# Bid Addendum 01

Project: UNC Charlotte Science Building:  
Early Package 1  
Existing Building Heating Conversions

Date: November 20, 2017

Prepared by: Mike Romot, AIA, LEED BD+C

**C-401**

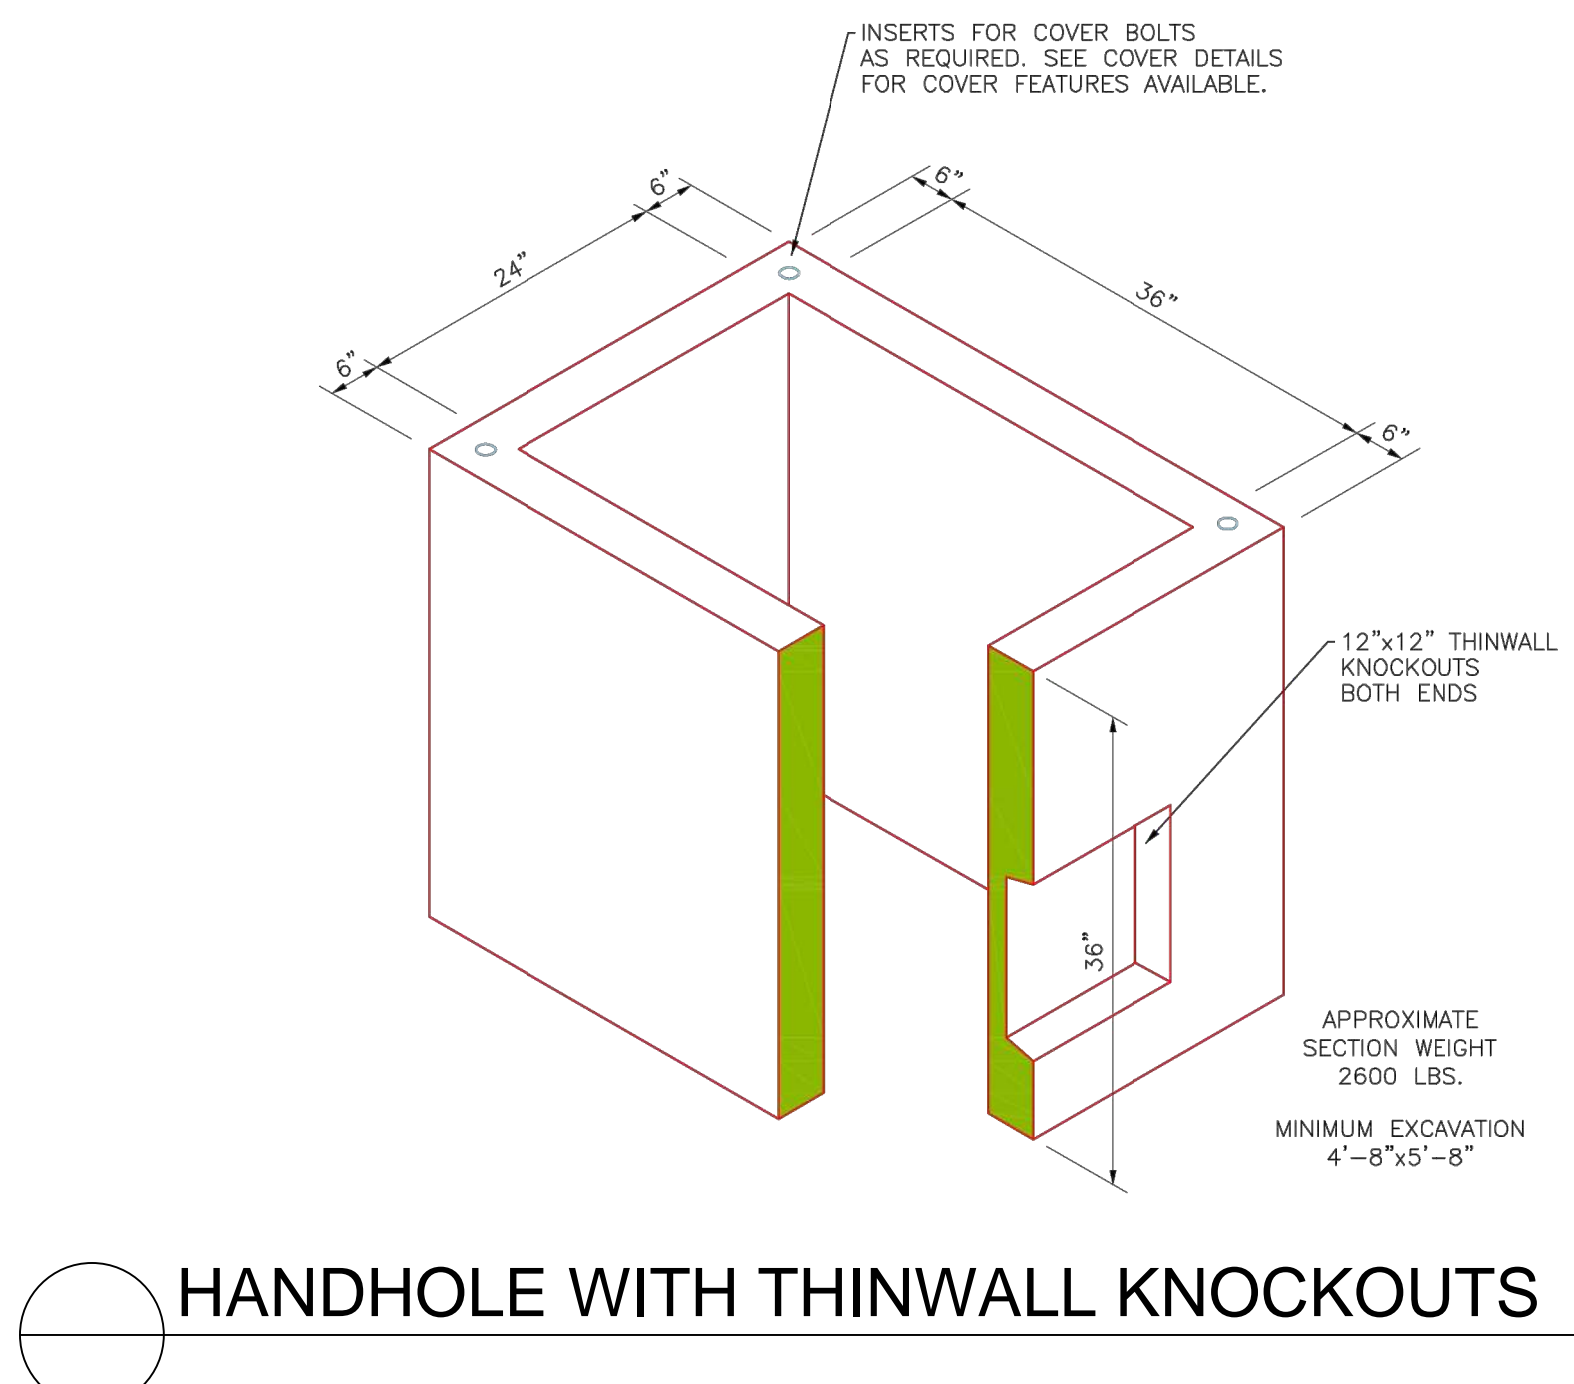
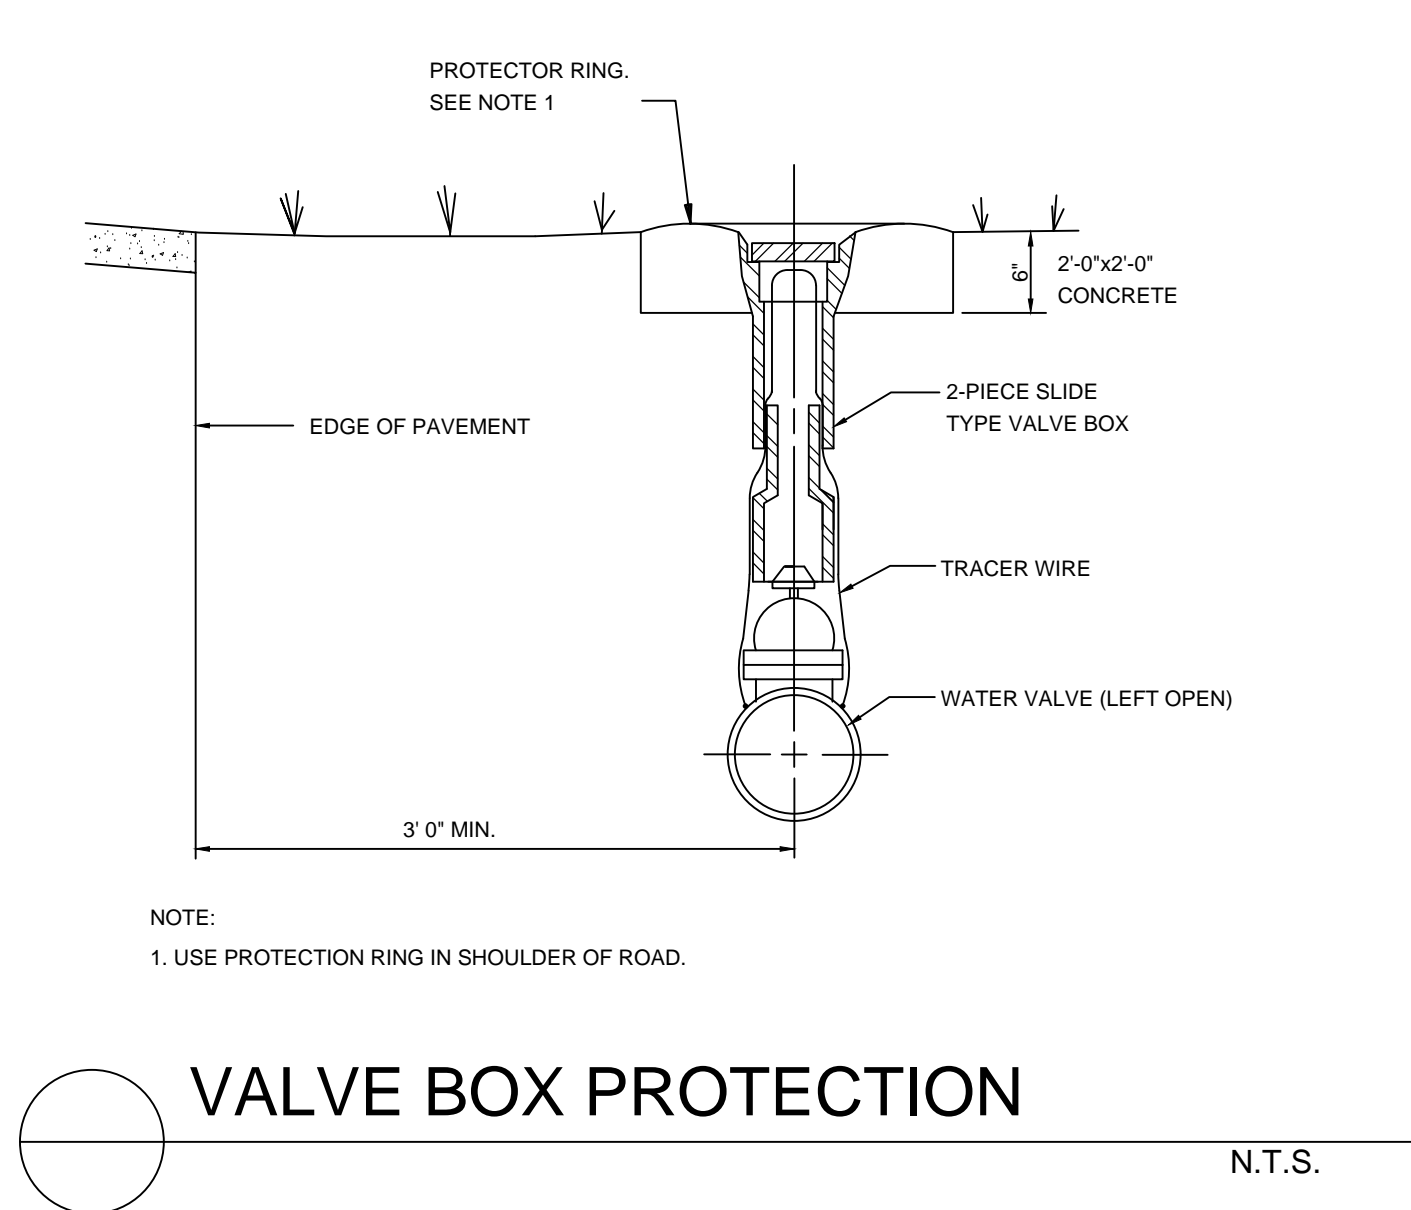
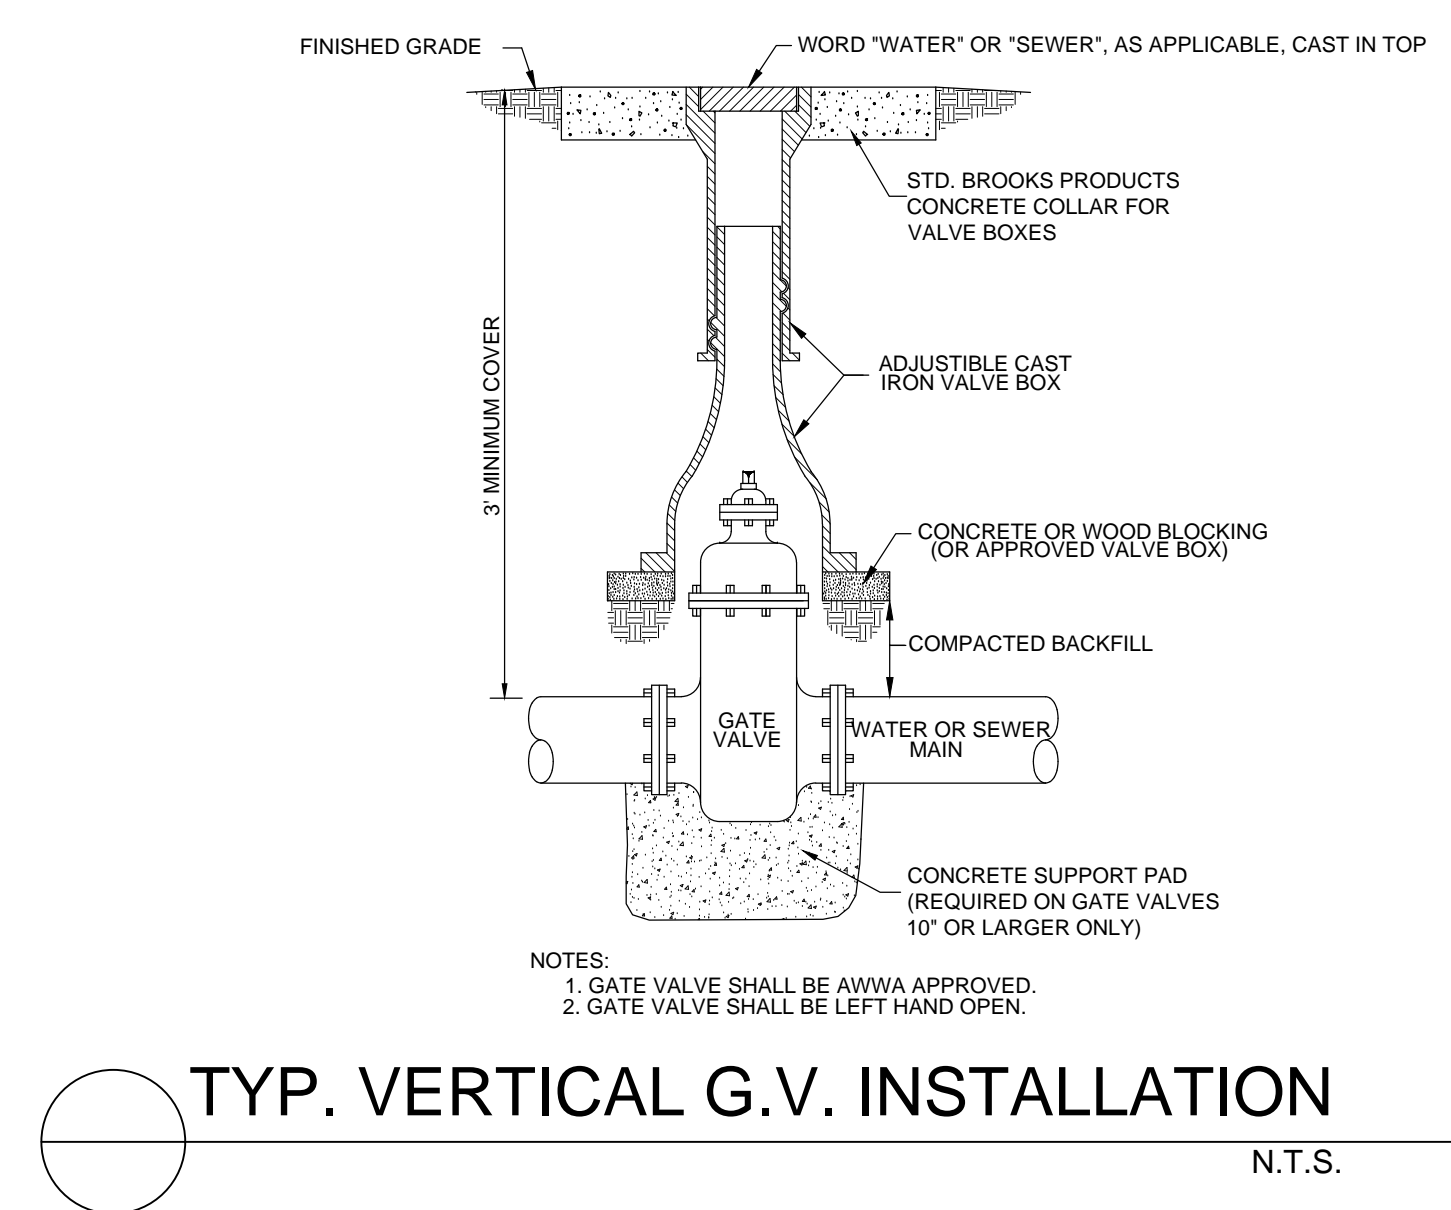
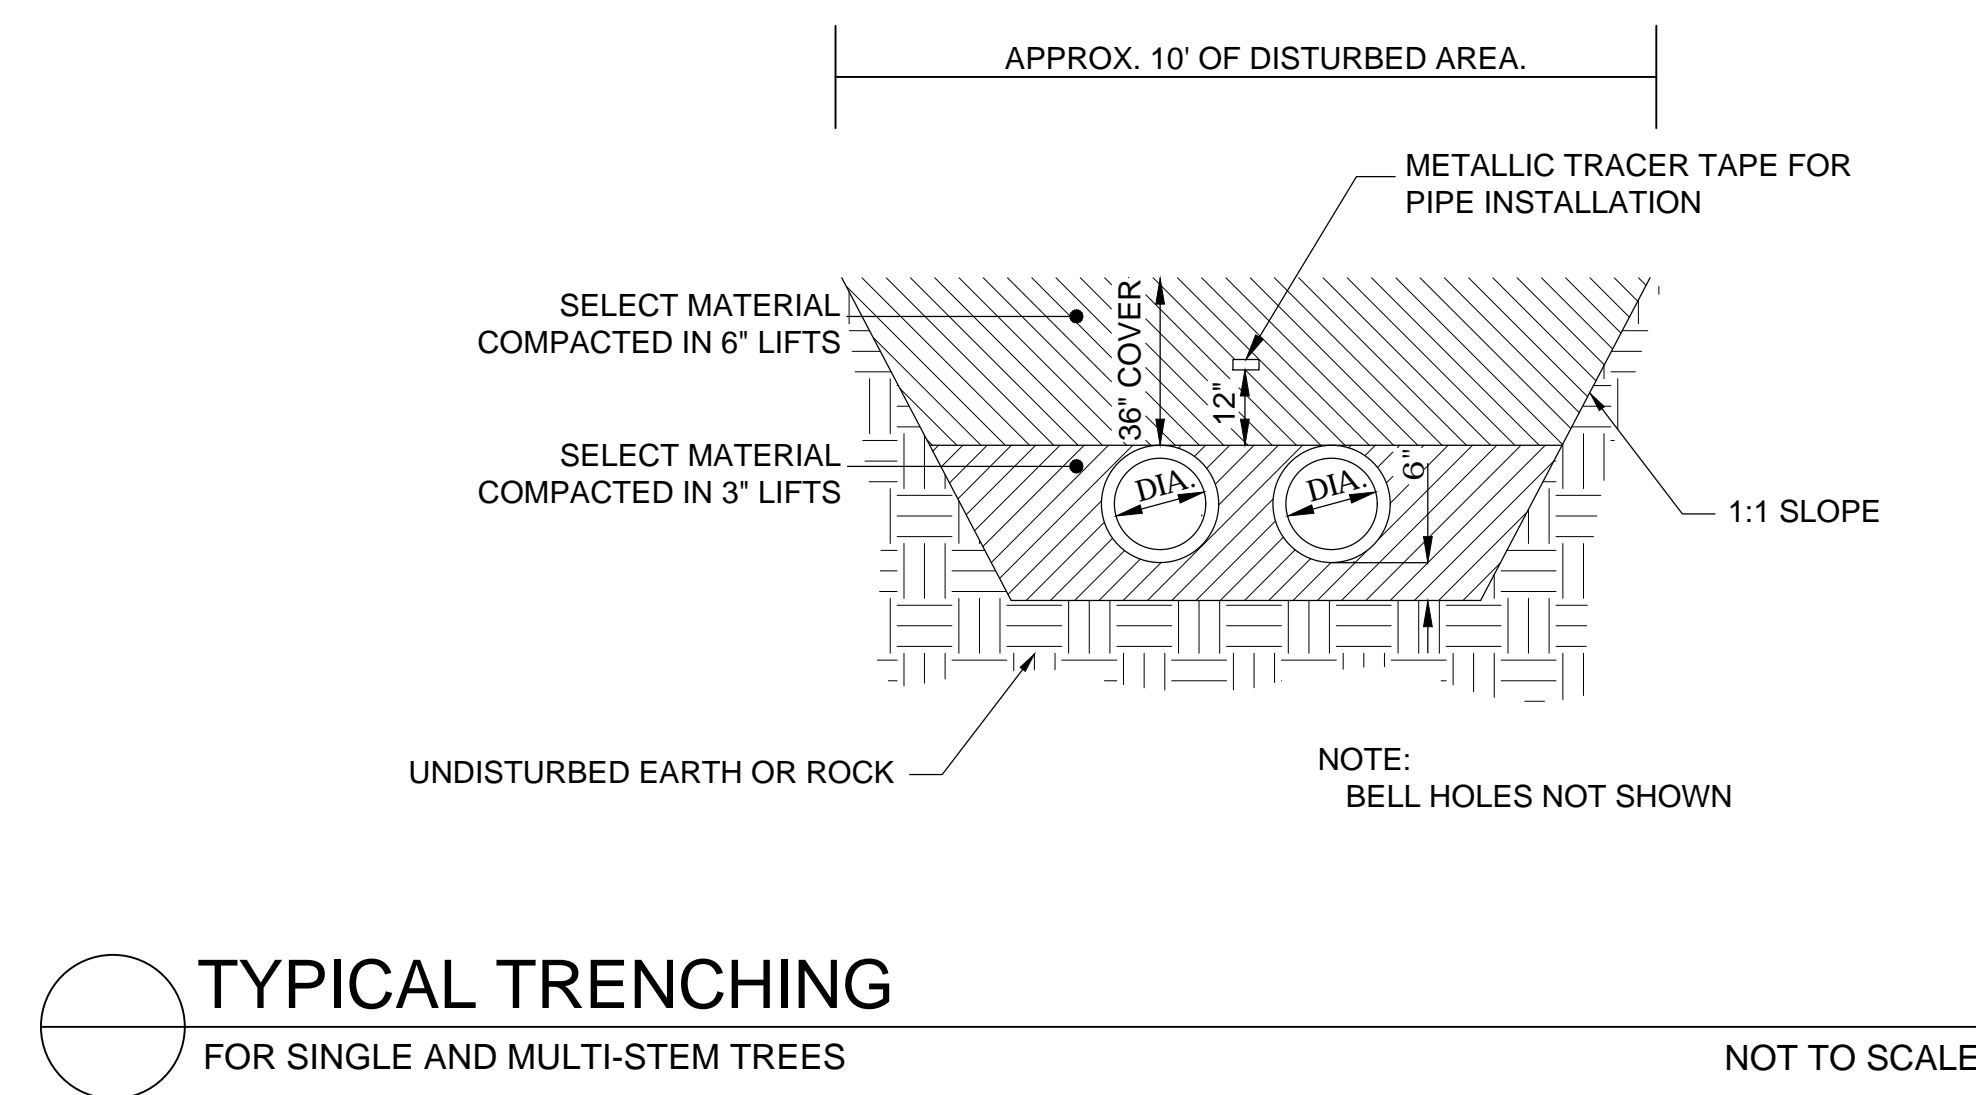
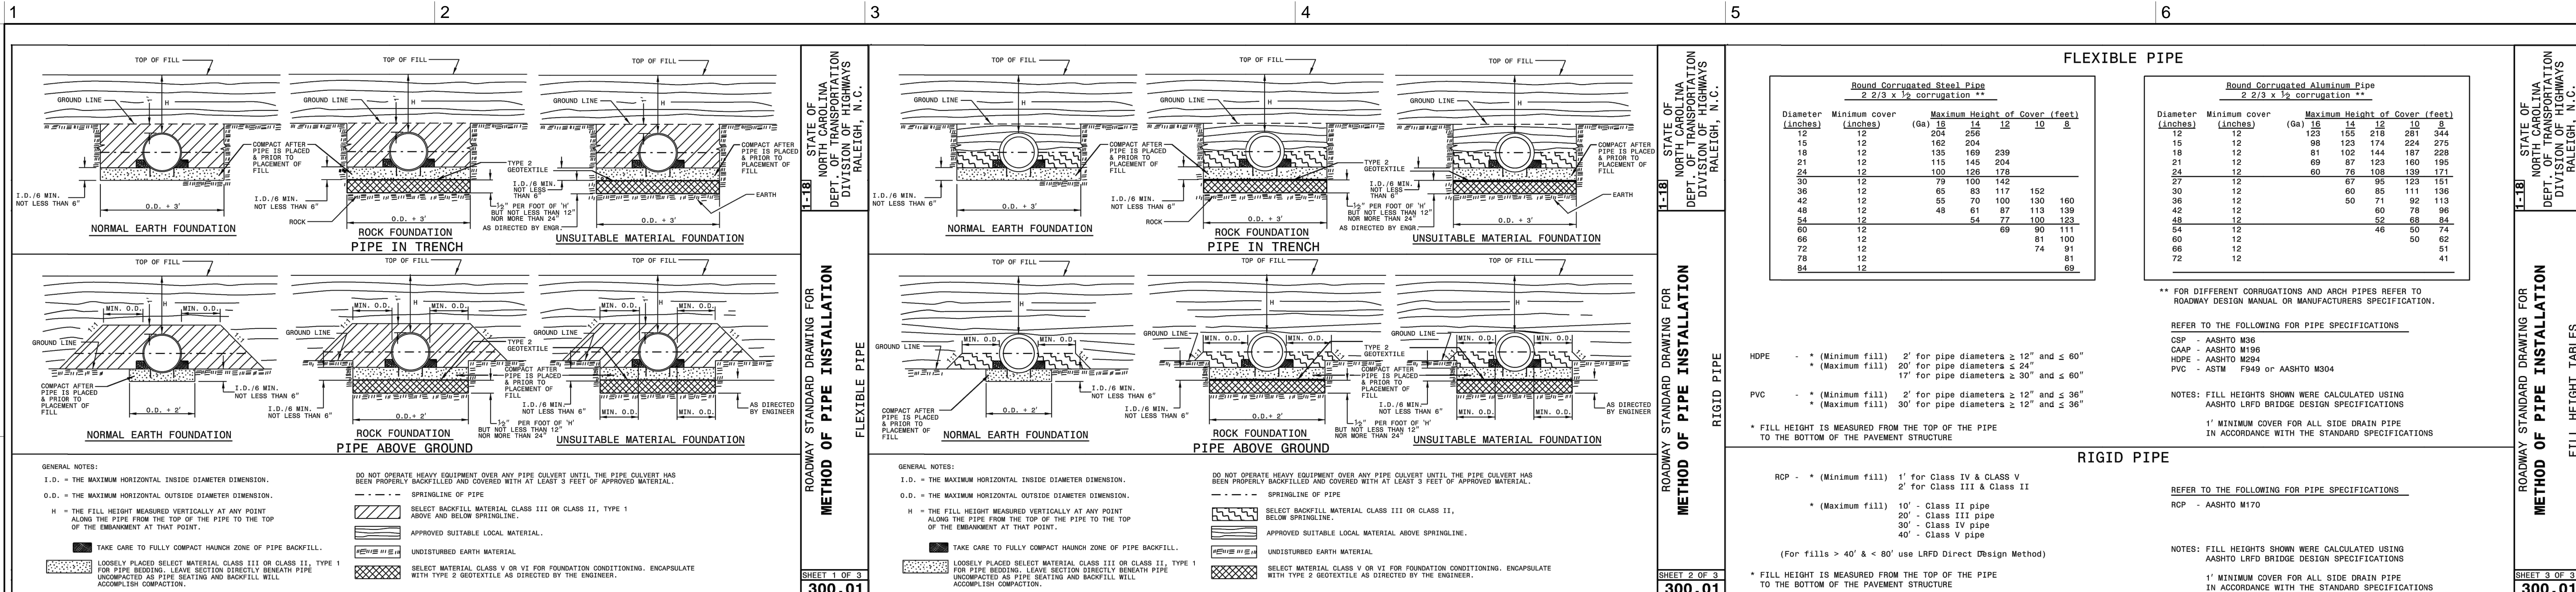
1. **Hot Water Valves** (Drawing Sheet C-400): Provide specifications and details on hand holes for 10" heating hot water valves shown at the temporary boiler trailers.

Response: The requirements for the below grade valves are described on drawing ME001. The drawings state to provide valves below grade with extensions and donut and valve box. Typical valve box detail has been added on drawing C-401.
